Access Compliance Report Public Rights-of-Way (Curb Ramps)

Intersection ID: 25251 Main Street: JOHNSTON_RD Cross Street: OAKBROOK_DR Location: NW **Overall Compliance: No** ADA ID: 80A848256654 Ramp Type: Perp Initial Pass/Fail: Fail **Severity Score:** 25

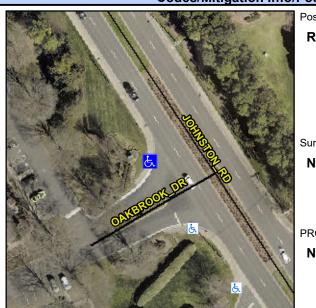
Possible Solutions:
Remove & Replace Entire Ramp.
Surveyor Notes:
N/A
N/A
PROW/ADA:
Not Found, R304.2.2, R304.5.3

Field Measurements/Component Compliance							
Compliance Description		Data	Comp	liance	Description	Data	
N/A	Ramp Length (in)	60.0	No	Ramp	Slope (%)	9.2	
Yes	Ramp Width (in)	48.0	No	• Ramp XSlope (%)		5.1	
N/A	Flare Type LT	N/A	N/A	/A Flare Type RT		N/A	
N/A	Flare Slope LT (%)	N/A	N/A	Flare Slope RT (%)		N/A	
N/A	Flare Traversable LT?	N/A	N/A	Flare Traversable RT?		N/A	
N/A	Landing Length (in)	N/A	N/A	DWS Provided?		N/A	
N/A	Landing Width (in)	N/A	N/A	DWS Contrast?		N/A	
N/A	Landing Slope (%)	N/A	N/A	DWS	Length (in)	N/A	
N/A	Landing X Slope (%)	N/A	N/A	DWS	Full Width?	N/A	
N/A	Landing Curb? (Y/N)	N/A	N/A	DWS	Offset (in)	N/A	
N/A	Shared Landing?	N/A					
N/A	Gutter Ponding?	N/A	N/A	Gutte	r Slope (%)	N/A	
N/A	Gutter Lip Ht (in)	N/A	N/A	Gutte	r X Slope (%)	N/A	
N/A	Painted X Walk1?	No	N/A	Painte	ed X Walk2?	N/A	
	X Walk 1 Direction	To SE		X Wa	lk 2 Direction	N/A	
N/A	X Walk 1 Width (in)	N/A	N/A	X Wa	lk 2 Width (in)	N/A
